From: William Kelly <William.Kelly@leics.gov.uk>
Sent: 03 February 2025 15:53
To: Laura Ashton
Cc: Planning Folder New
Subject: 24/00632/FUL | Highway Verge Hinckley Road / Desford Road Enderby
Attachments: Outline Construction Environmental Management Plan.pdf; Mitigation Area A.png; Mitigation Area C.png; Mitigation Area D Part 1.png; Mitigation Area E Part 1.png; Mitigation Area B.png; Mitigation Area D Part 2.png; Mitigation Area E Part 2.png

24/00632/FUL | Installation of an underground grid connection cable within the highway verge to connect Enderby Substation (Cross-boundary with Blaby District Council) | Highway Verge Hinckley Road / Desford Road Enderby

Archaeological considerations

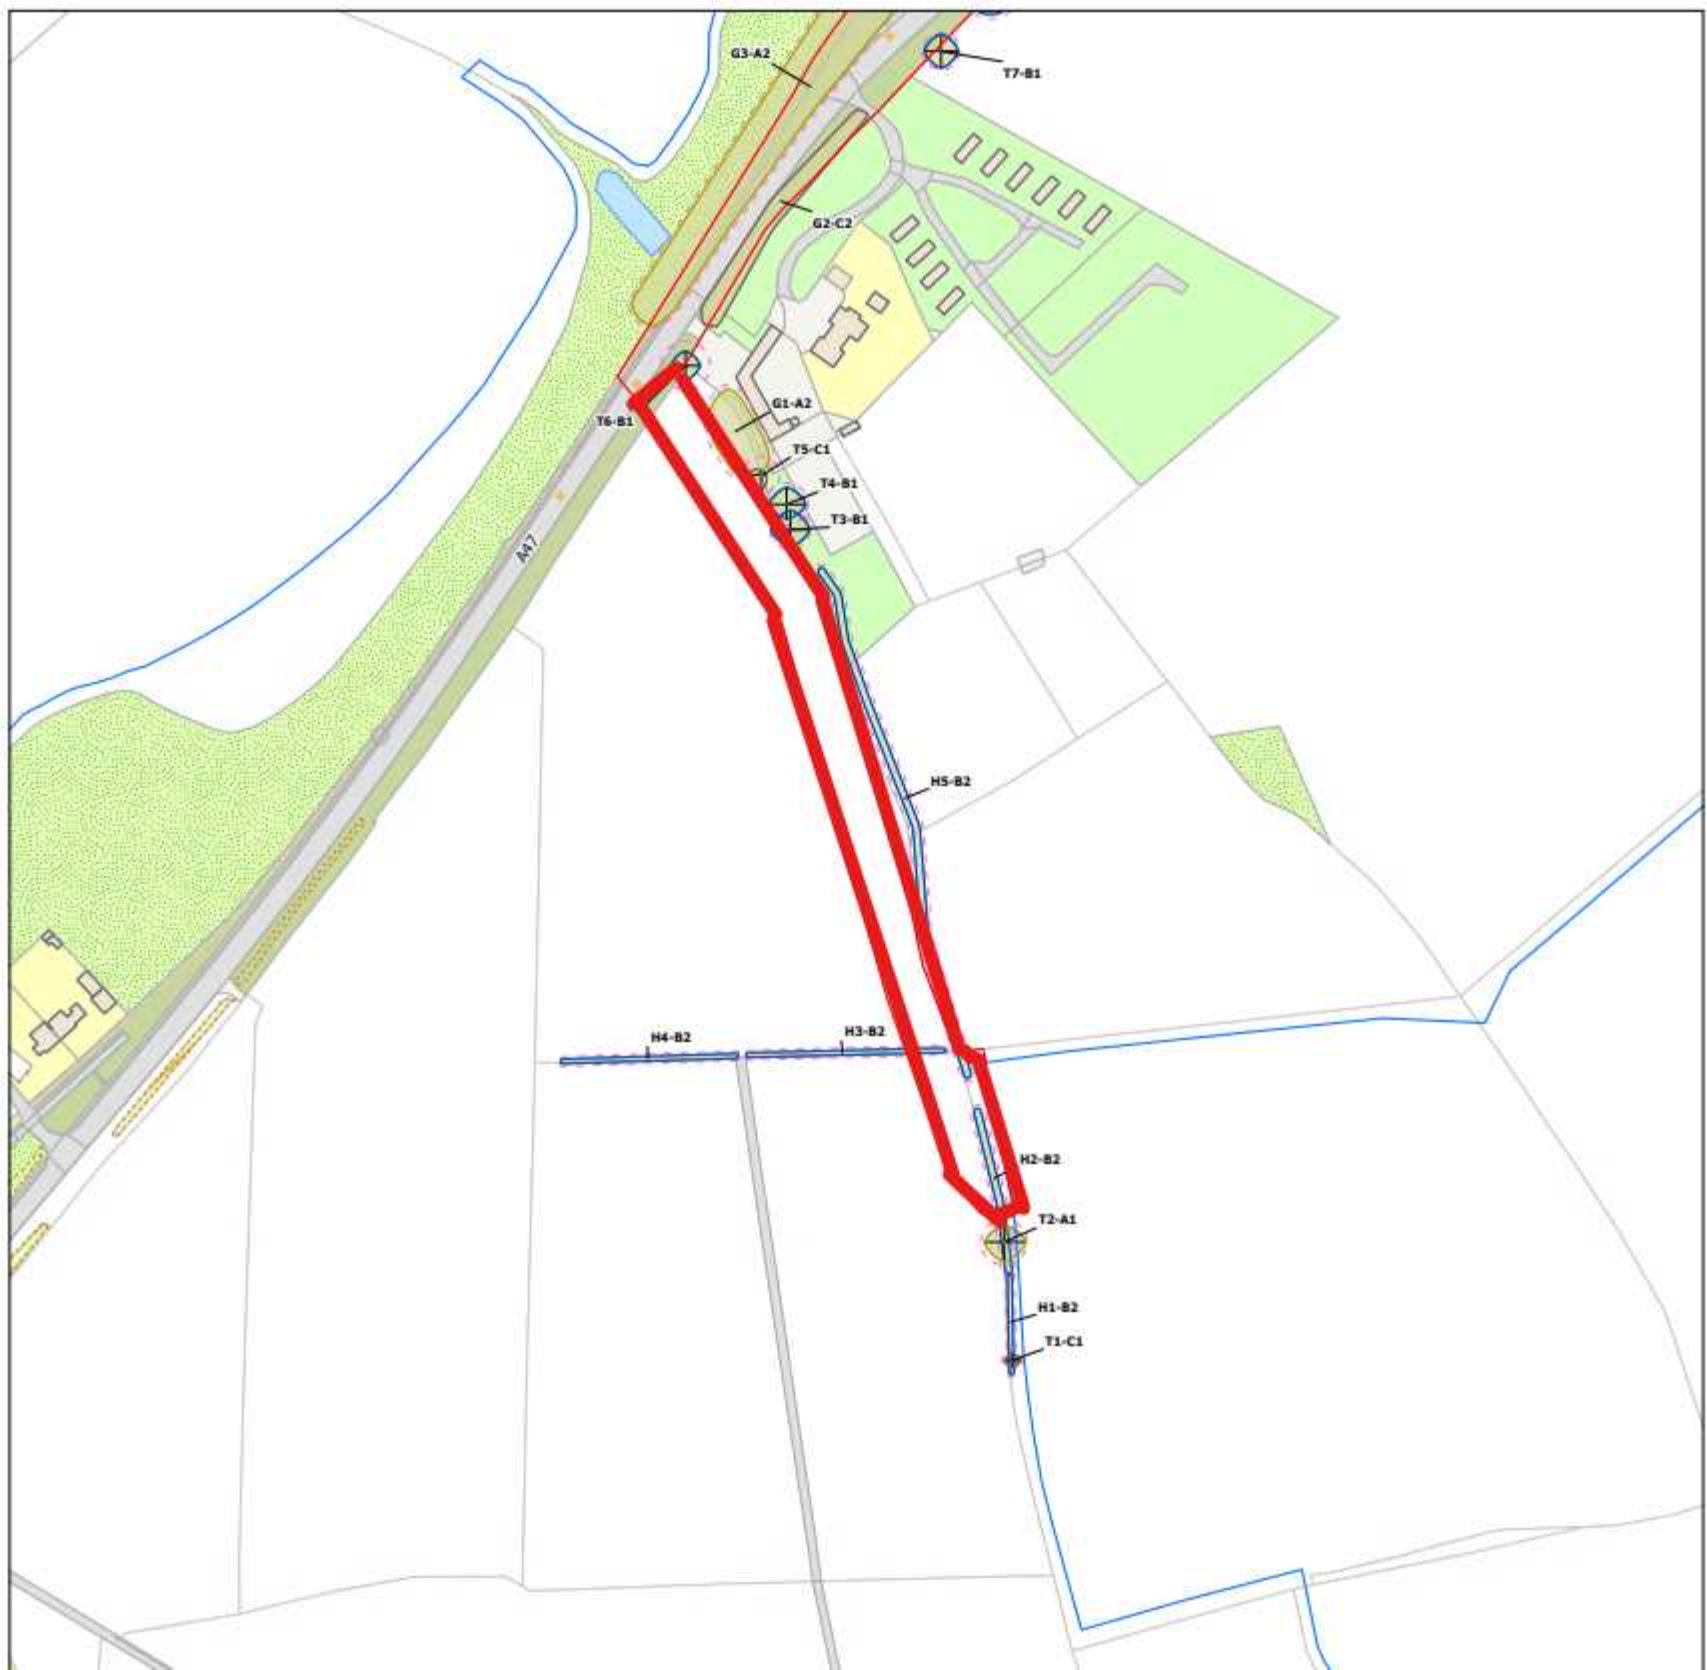
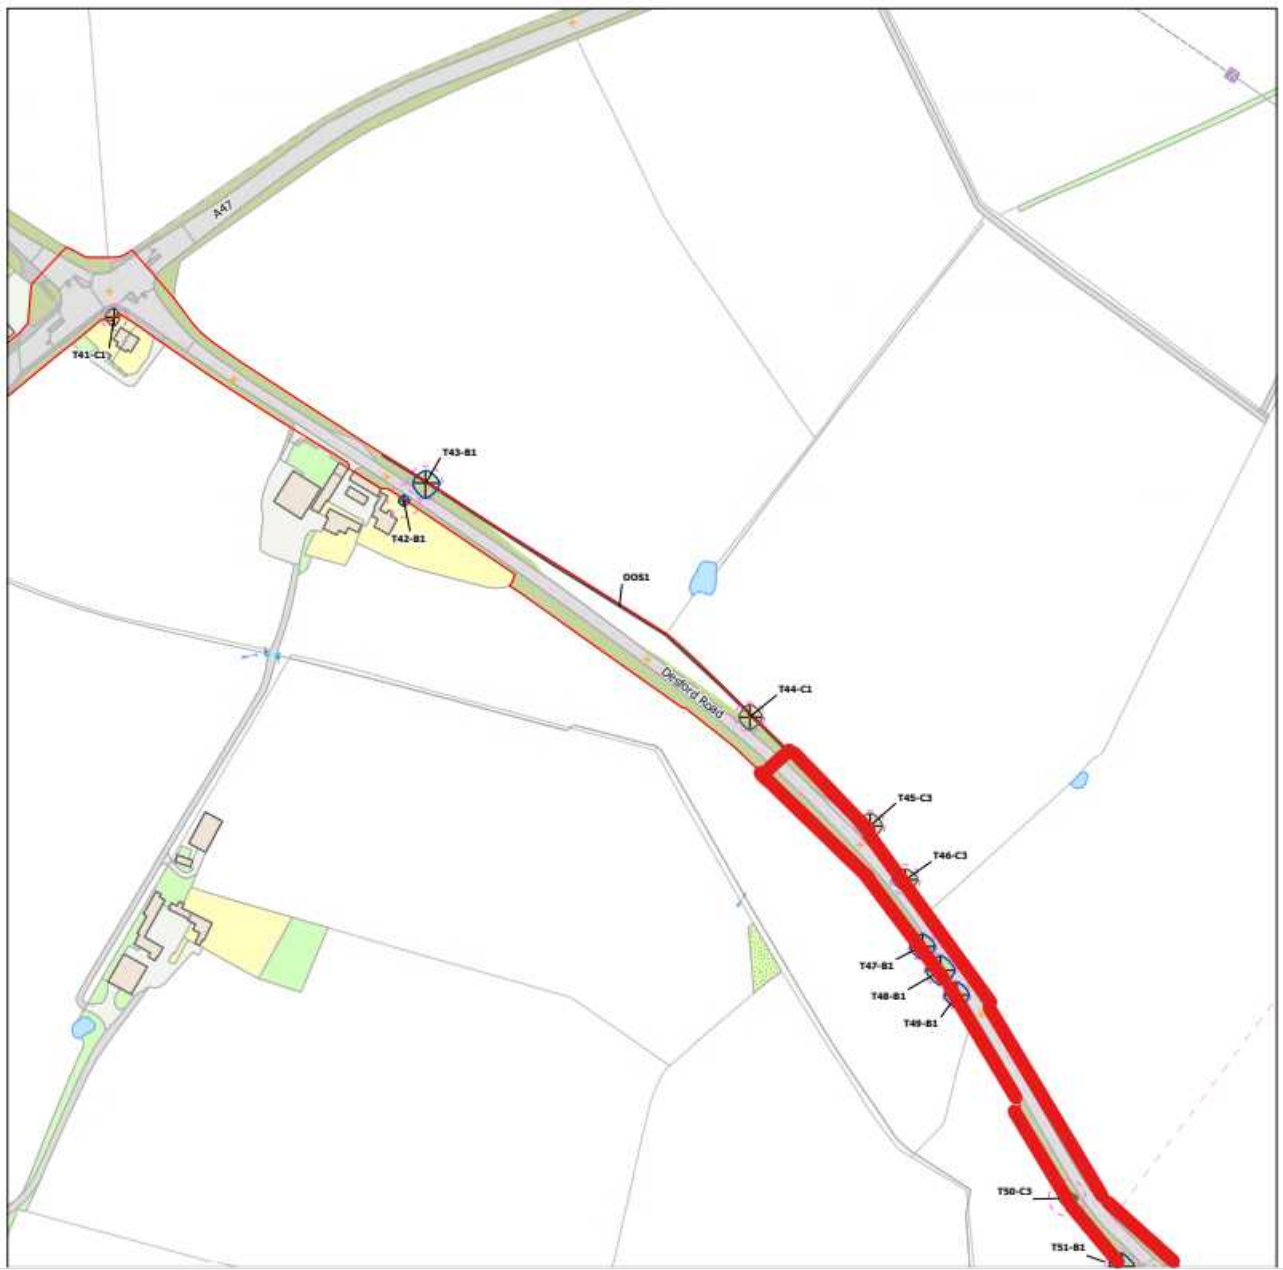
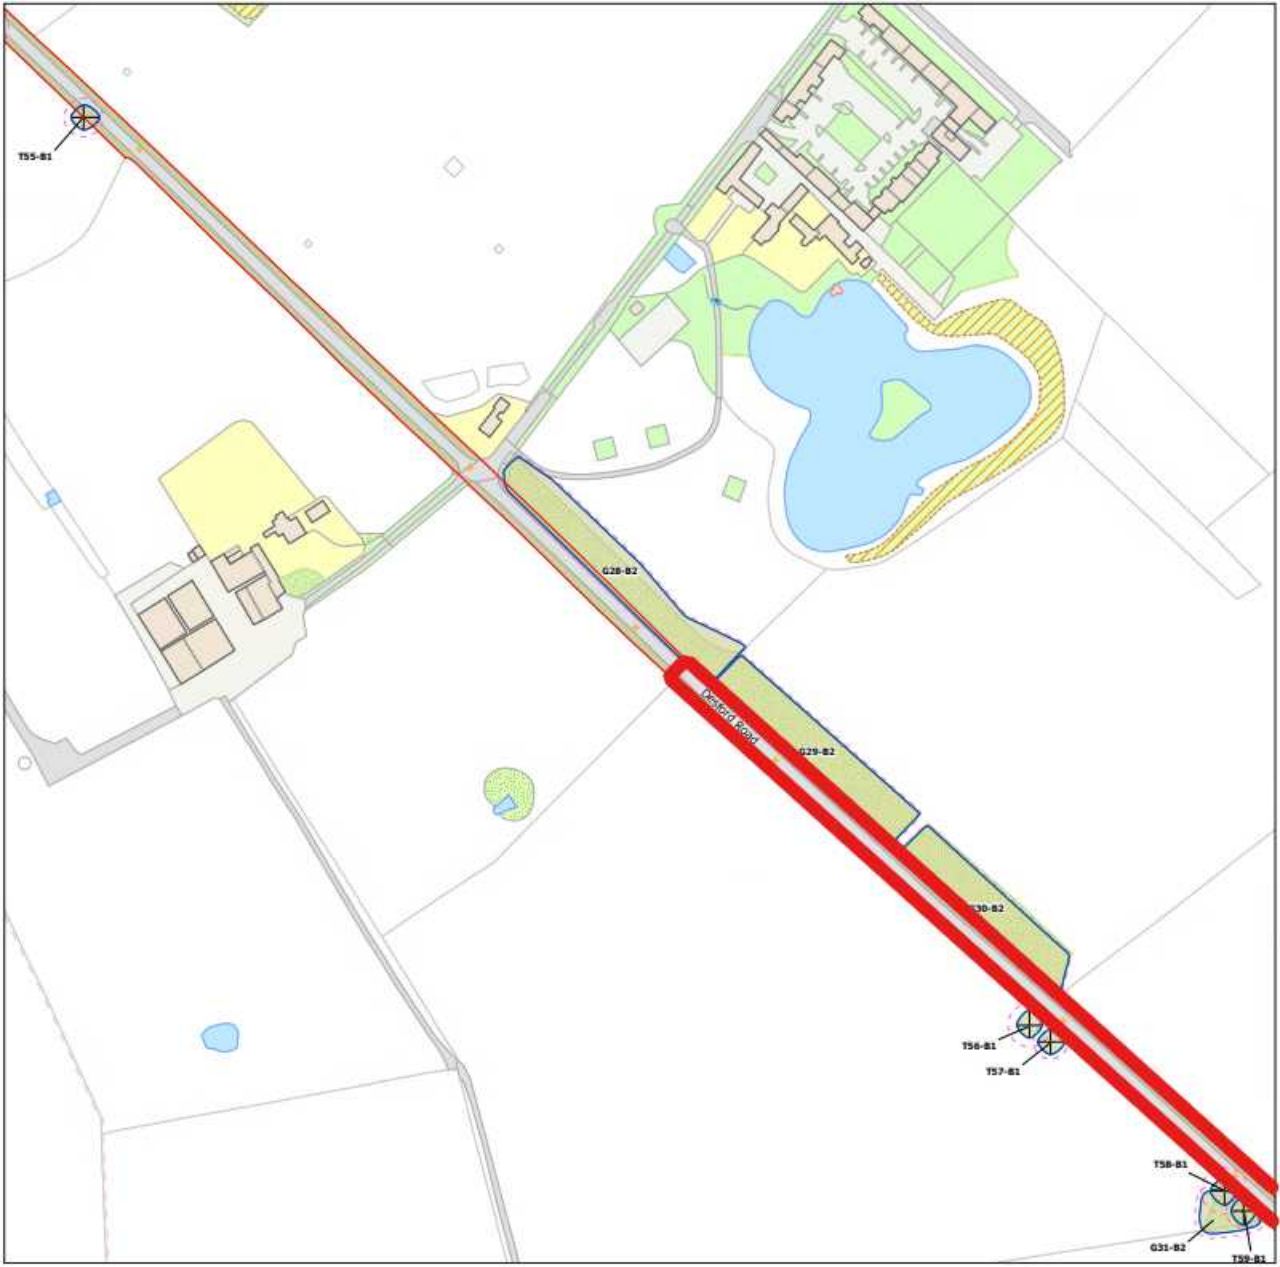
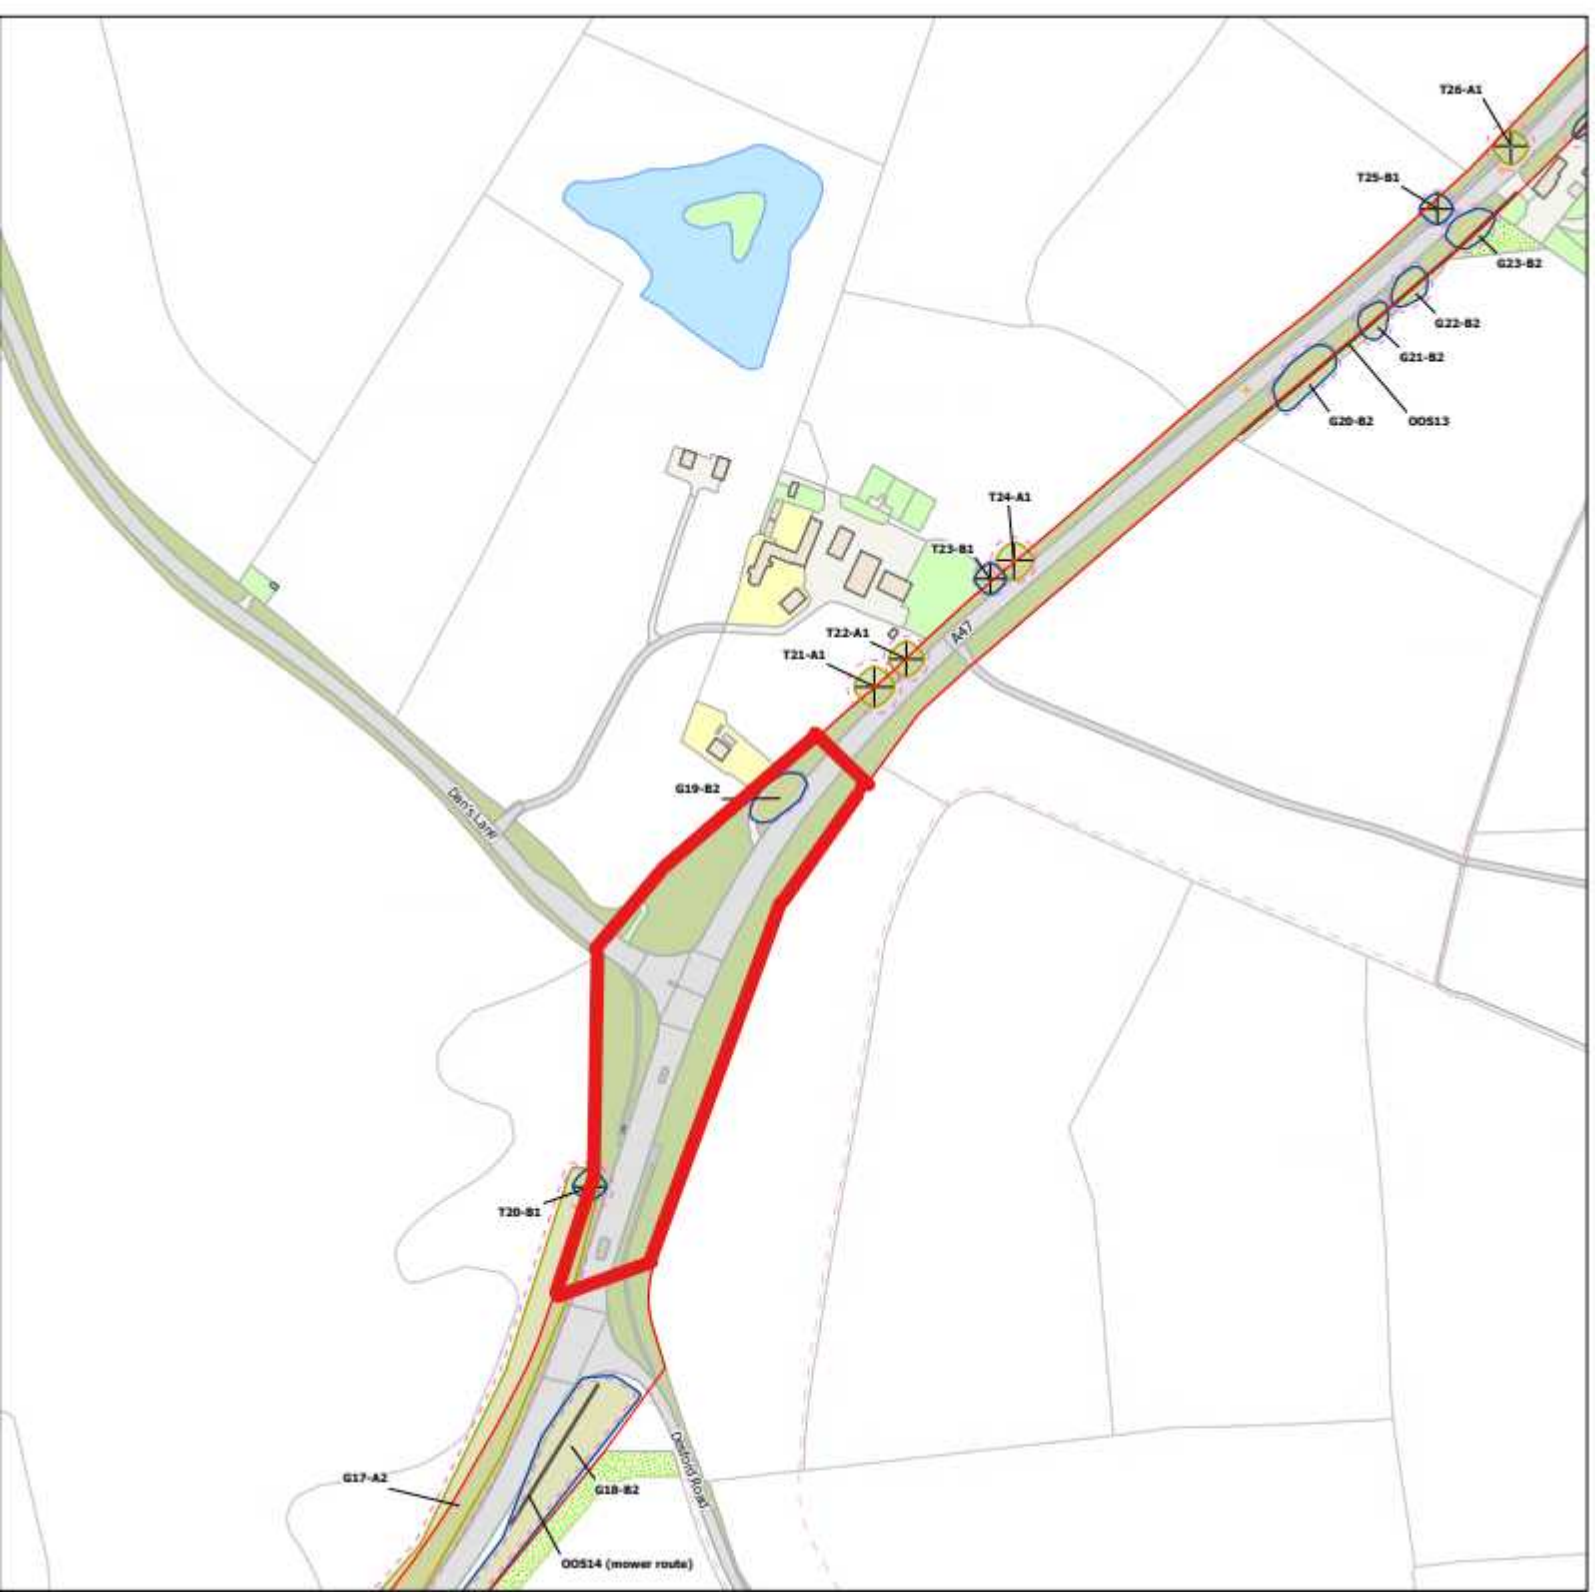
Please see the attached plans which illustrate the areas of known archaeological potential where a Strip, Plan and Record excavation should be undertaken; between Hill Farm solar farm and the A47 (Mitigation Area A); intersection of Dan's Lane/A47 (Mitigation Area B); intersection of the A47 within the Desford Cross Roads area (Mitigation Area C); area adjacent to Narborough Wood Cottage (Mitigation Area D); section of the route at Billsdon's Hollow

(Mitigation Area E). The applicant may also choose to undertake further exploratory trial trenching within these areas to refine the extent of the Strip, Plan and Record excavations.
